**MUNICIPAL SERVICES CENTER, COUNCIL CHAMBER
3600 TREMONT ROAD**

2. Variance/Conditional Uses

3. Development/Site Plans

- a. Glamm Dental, 2164 Riverside Drive (DEV-02-23) - Review of an Amended Final Development Plan for exterior site improvements to accommodate a dental practice expansion.

3846 Waldo Place

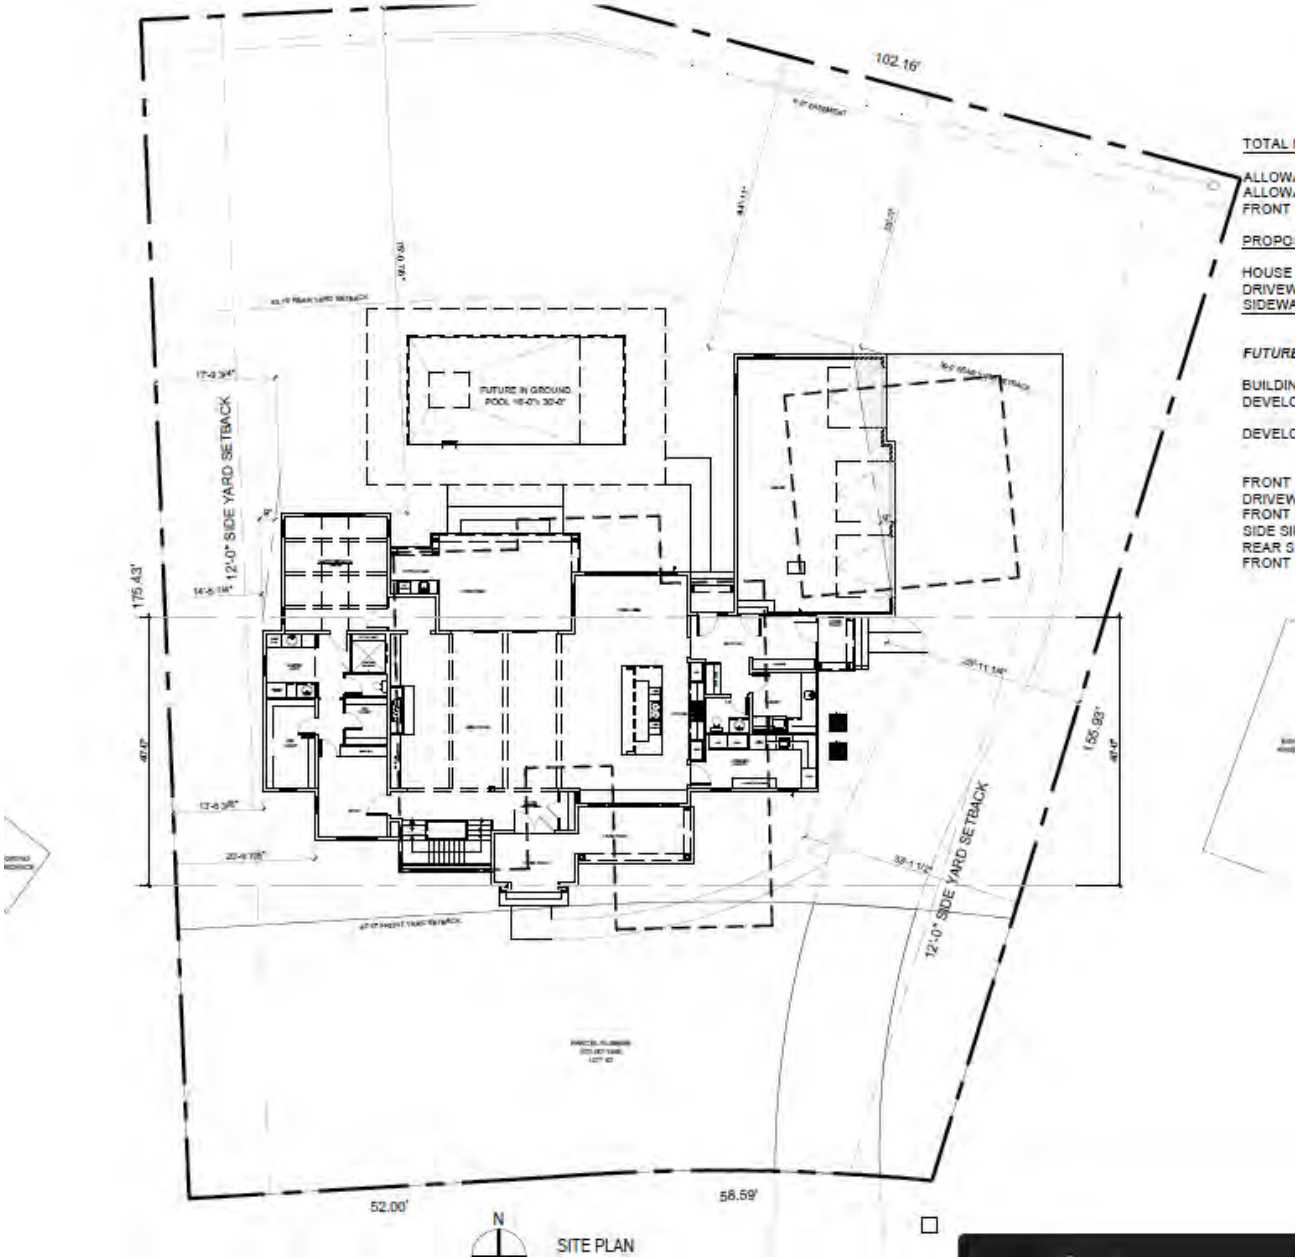
The building height calculation (per the Policy) would equate to a maximum height of 26 feet, eight feet below the proposal. Per 4.2 of the Policy calculation, the median height of the street segment and rear homes is 17.3 feet, which results in a 26-foot height limit when multiplied by 150 percent. The applicant has indicated that they cannot modify the proposed home plans to reach a 26-foot building height. The "extra height allowance" outlined in 4.3 of the Policy does not apply here because at least two unique conditions are not present. A survey of the entire area (and street segment per 4.4 of the Policy) proves that stucco homes are present, but all have significantly more stone on the front elevation than is proposed; there are no full stucco homes. Therefore, a variance has been requested to the City's design standards.

Other than providing an entirely new home plan design, there are three options to reduce the severity of the variances requested:

- 1) The floor heights could be reduced, saving between 12 and 24 inches of overall building height and mass. The City's third-party architect was unsure this would really make much of a difference but would bring the height down some.
- 2) The roof pitch could be modified from 9/12 to 8/12, which would drop the height by approximately 1'-2". The City's third-party architect felt this would actually have a negative impact on the design and significantly increase costs due to truss roof construction modifications. The applicant is amenable to this option.
- 3) Additional stone could be added to the front elevation to better complement the neighborhood.

Staff reviewed the application and plans, visited the site, and discussed it with the applicant and concerned neighbors. This is the first application that tests the City Manager's Policy on Neighborhood Compatibility. This Policy is meant to supplement the City's Residential Design Standards by offering guidance as to what compatibility looks like. Simply, because 4.2 and 4.4 of the Policy are not met, Staff has to determine that Article 7.17 is not being met. The applicant could make changes to meet 4.2 and 4.4, or seek a variance from BZAP as a result. This was specifically set up to allow the Board further review and a closer look to see if compatibility is or isn't met based on the application, ordinances and variance standards of approval. Other than building height and exterior materials, the proposed home meets all of the Policy's measures, including those to reduce mass and potential impacts on adjacent property.

This area has slowly been in a transition between the original 1950s-60s homes and replacement homes built within the past two decades. These homes have largely done a good job of blending into the neighborhood and not negatively impacting existing nearby homes, proving that taller and more thoughtfully designed homes can be harmonious with lower, ranch-style homes. Largely as a result of the City's third-party architect's recommendations, Staff would like to see a reduction in building height and additional stone be added to the front elevation before support for the application can be offered. If these two things were to occur, Staff believes that the granting of the variance would not be precedent-setting because the design meets all of the measures meant to reduce the height, massing and bulk of homes of the Policy, especially as they relate to adjacent lower homes by stepping the building down as it reaches the outer ends of the home. There are two existing homes that would be taller than the proposed home directly across the street from the subject property.

Aerial

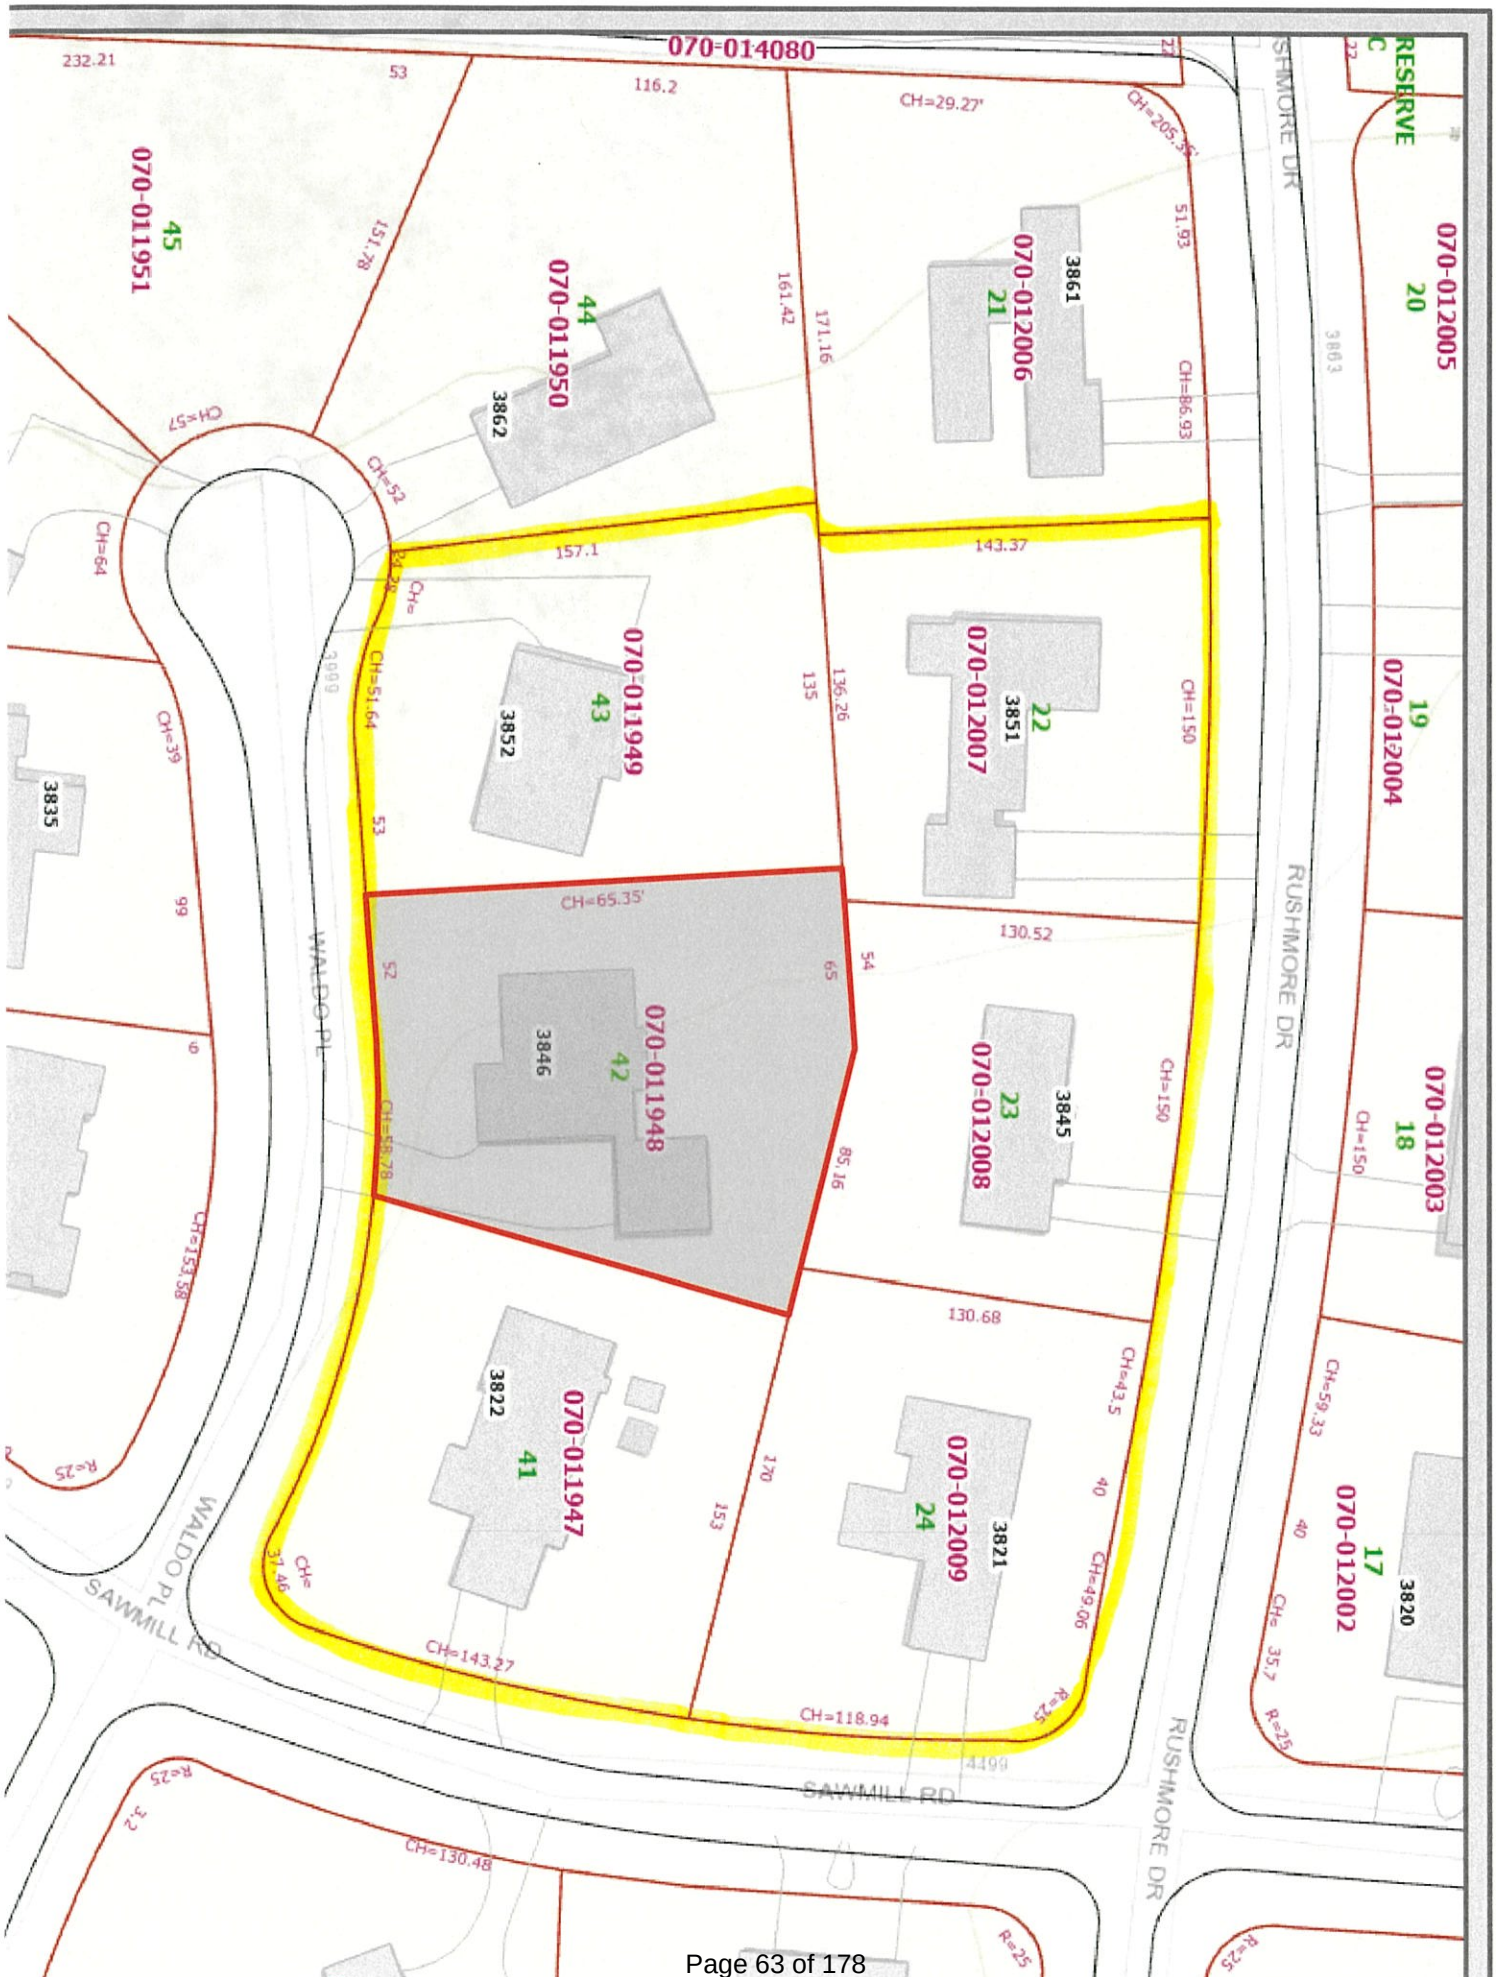
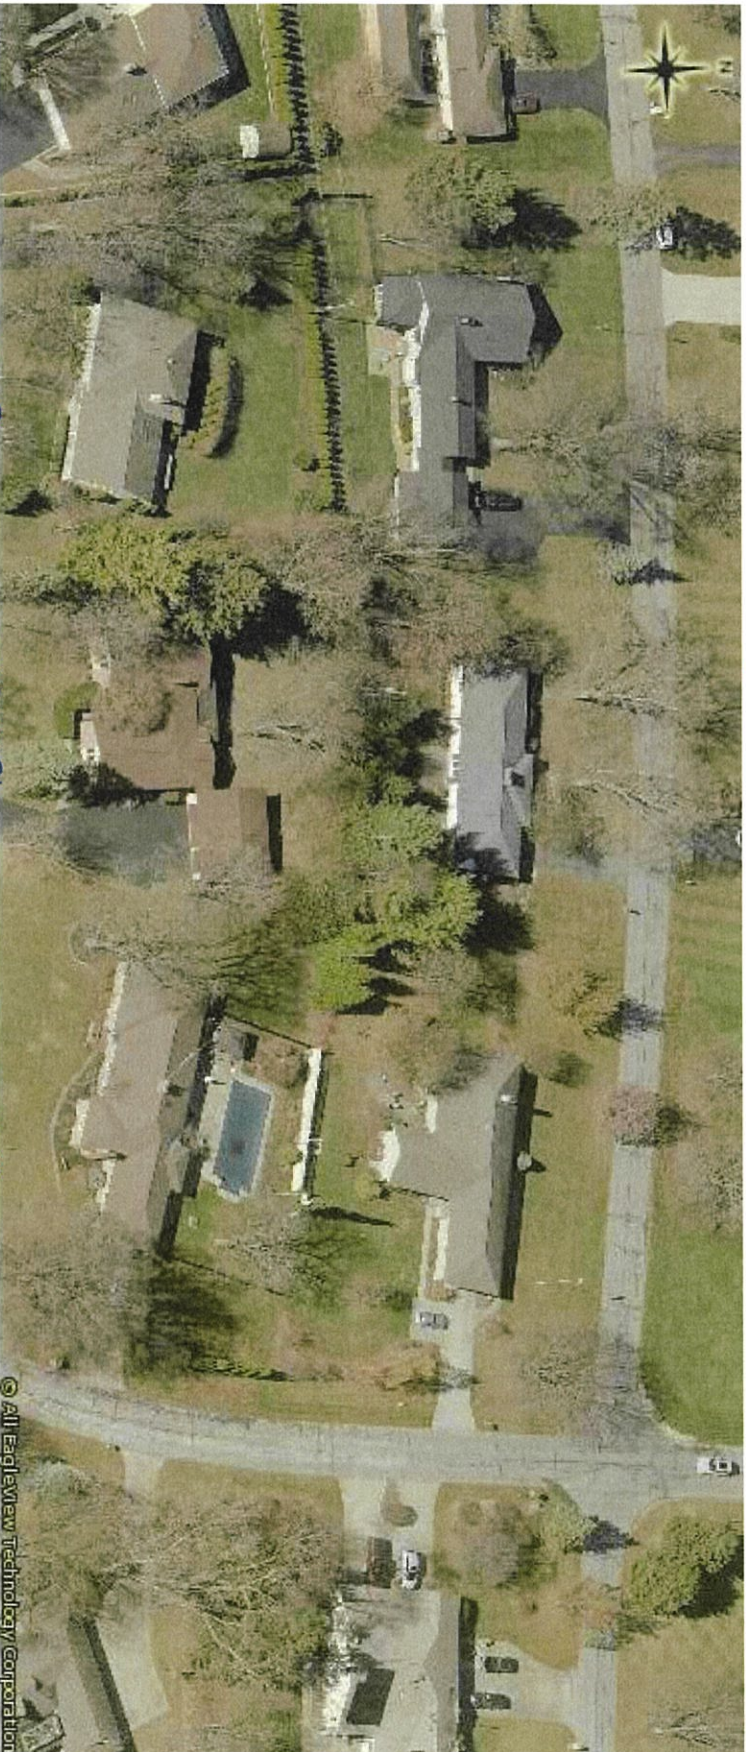
My name is Lisa Schubert and I live in a ranch home at 3845 Rushmore Drive directly behind the proposed new build at 3846 Waldo Place, both located in Orchard View. I am concerned about the variance request made by the builders representing Carleton and Amy Nelson, the new owners of the Waldo property. In the variance request, the builders acknowledge that all surrounding homes are ranches. Nonetheless, the builder insists the existing character of the neighborhood will not change by building this proposed home of such dimension that it requires a variance to accommodate its scale, height, and massing. The house size is clearly at odds with the present building requirements and existing ranch homes surrounding it on similar sized lots. If the variance is granted, current homeowners will surrender some of their privacy and have the quiet enjoyment of their properties infringed upon.

Please note that the proposed build is already elevated from street level as they request a height variance. Even though several larger homes have recently been built in Orchard View, the two new larger homes on Waldo abut to a very large two-story home on Sawmill and are not surrounded by ranches. 3846 Waldo Place has a ranch to the east and a split-level to the west on Waldo and all the Rushmore properties affected are ranches. Pictures of the affected homes on Waldo and Rushmore are attached as well as a current view of the home being torn down. Many of the existing ranches in Orchard View have been updated while preserving the unique tranquility of Orchard View. Towering over other houses does not maintain or enhance the character of our subdivision.

As stated by the builder, a beneficial use of the property **can be obtained** without the variance being granted. And given the already large size, conforming to the existing building codes would be less intrusive and somewhat less overwhelming.

Glamm Dental

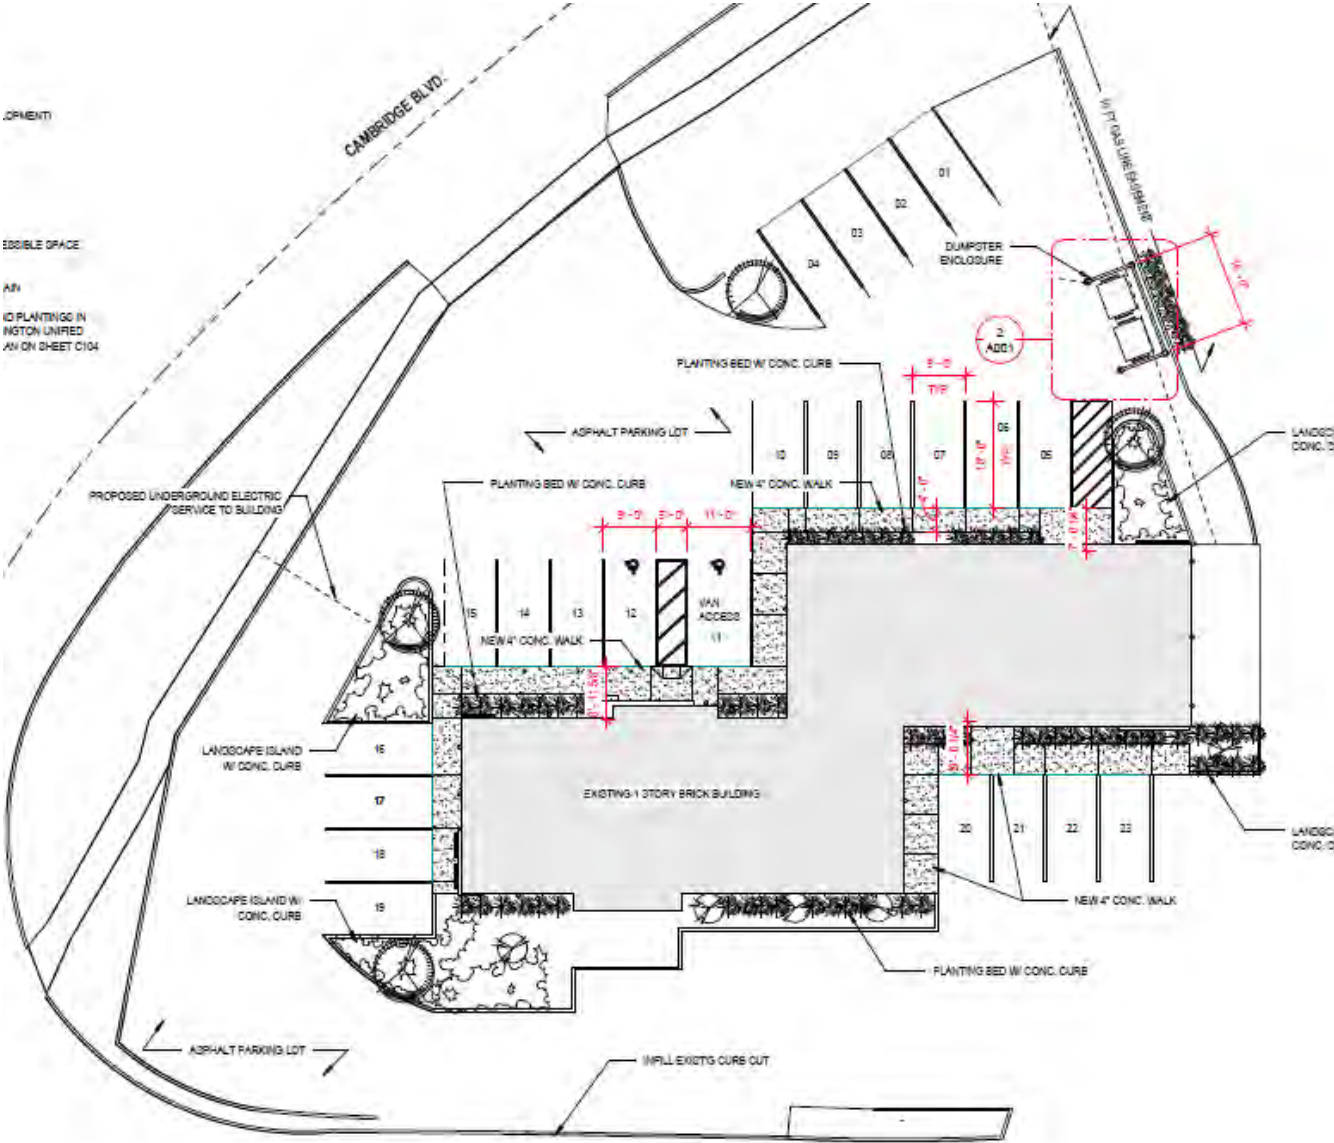
The proposal includes the renovation of the existing one-story office building, where Glamm Dental is expanding to take over the entire building. The building will undergo a significant transformation to create a more modern aesthetic with traditional exterior building materials. The site will be significantly improved as well, with revised access, new landscaping, and new outdoor lighting. A number of positive revisions have occurred since the July 5, 2023 BZAP Work Session.
